**LOST CREEK ISR, LLC**

**RE: Submittal of Non-Significant Revision #13 to Permit to Mine  
Lost Creek Project PT788**

INDEX SHEET FOR MINE PERMIT AMENDMENTS OR REVISIONS

MINE COMPANY NAME: Lost Creek ISR, LLC MINE NAME: Lost Creek PERMIT NO.: PT0788

**FIGURE OP-5a**  
**Project Water Balance**  
**Production Only**  
**Lost Creek Permit Area**

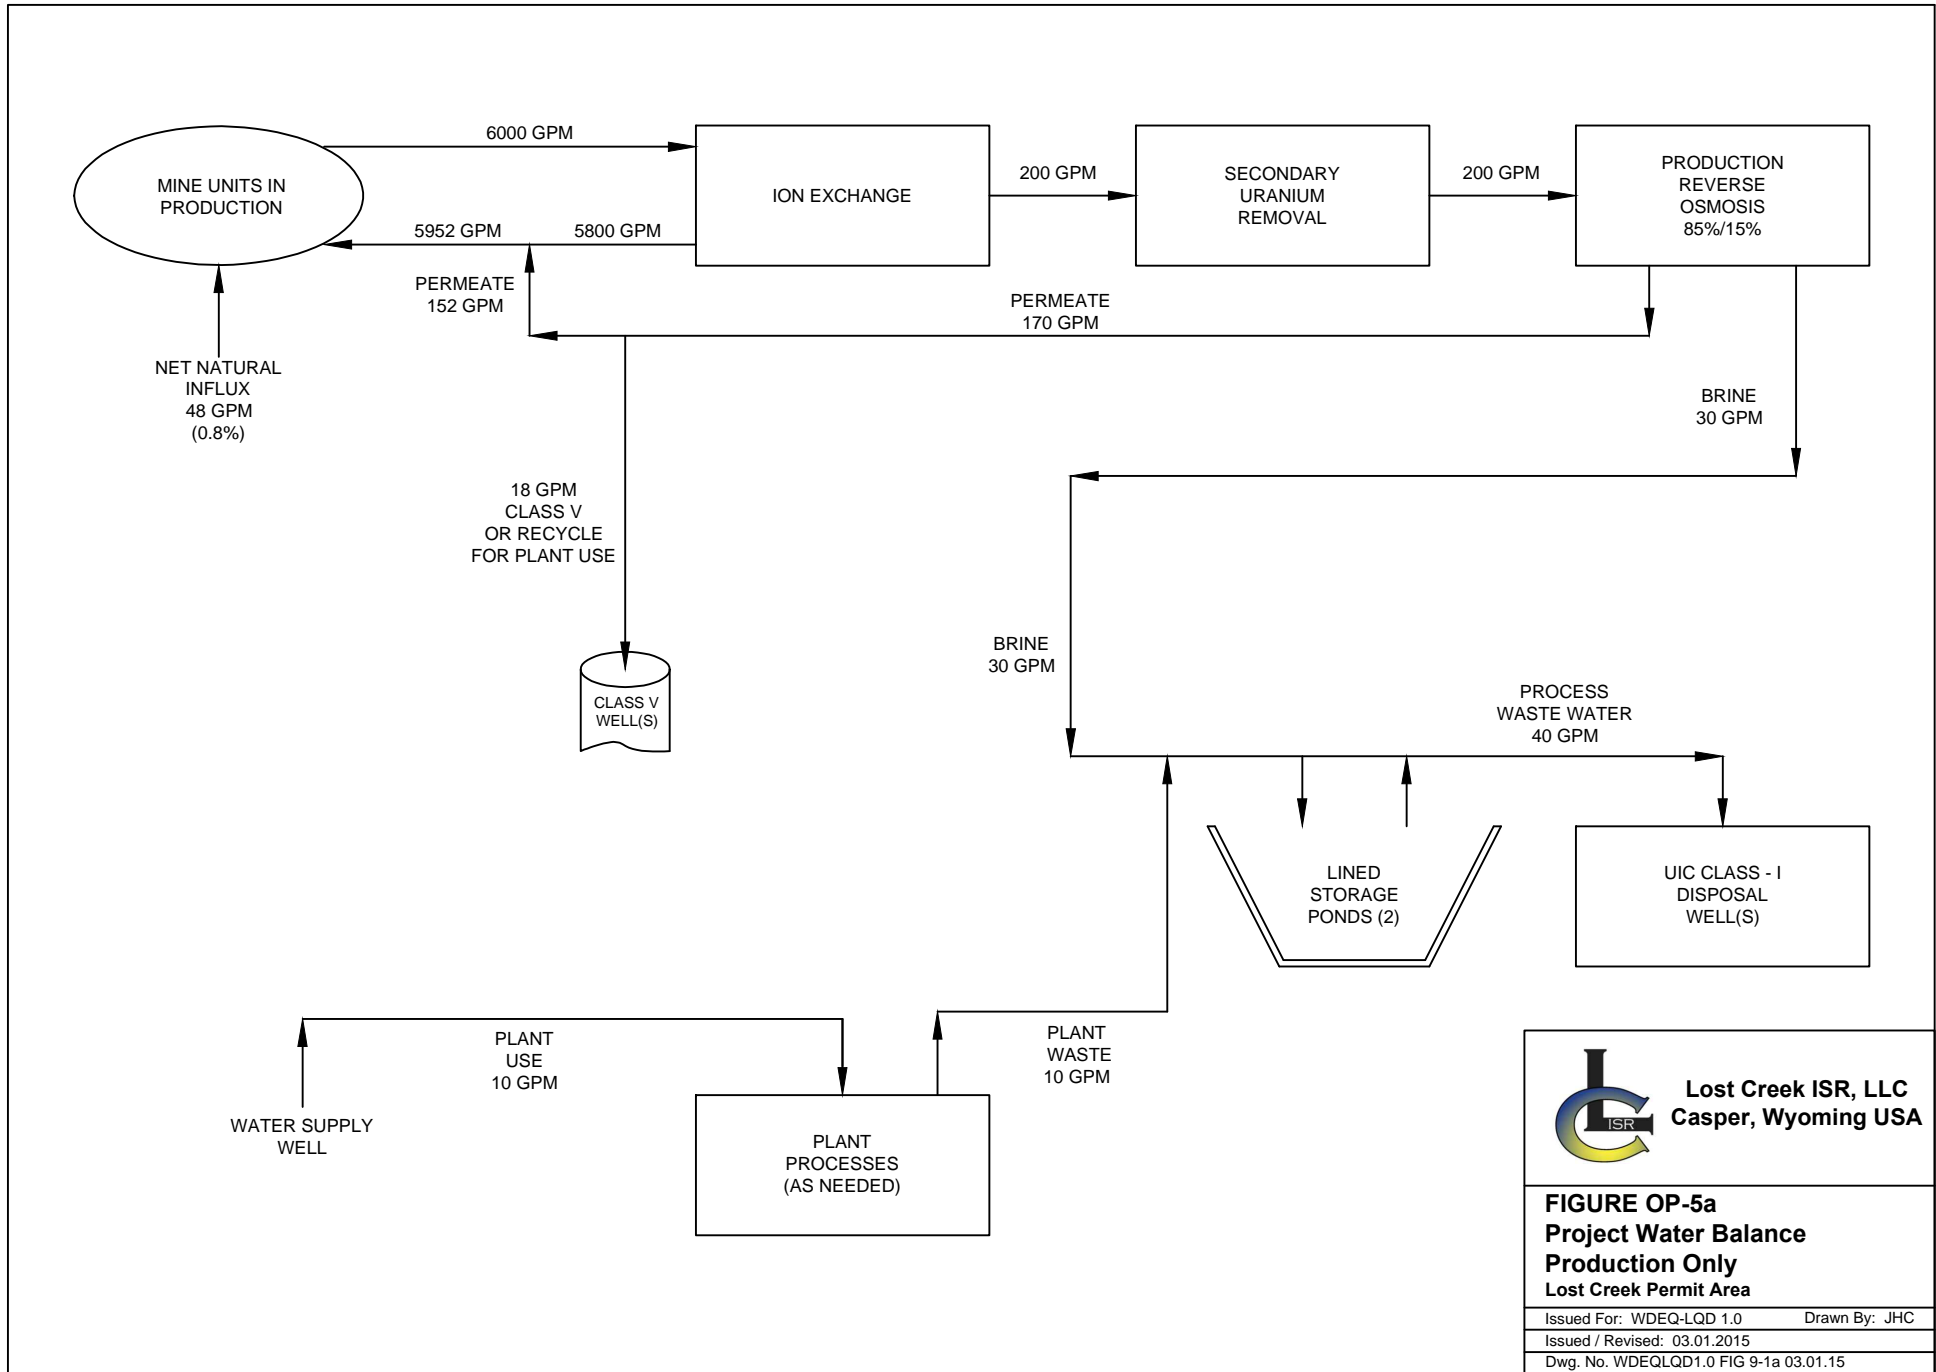
| Permit to Mine Volume 5 – Operations Plan | Figure OP-5a – 5f (Oct09)                         | Figure OP-5a – 5f (Mar15)                          | Added Class V disposal option graphic                           |
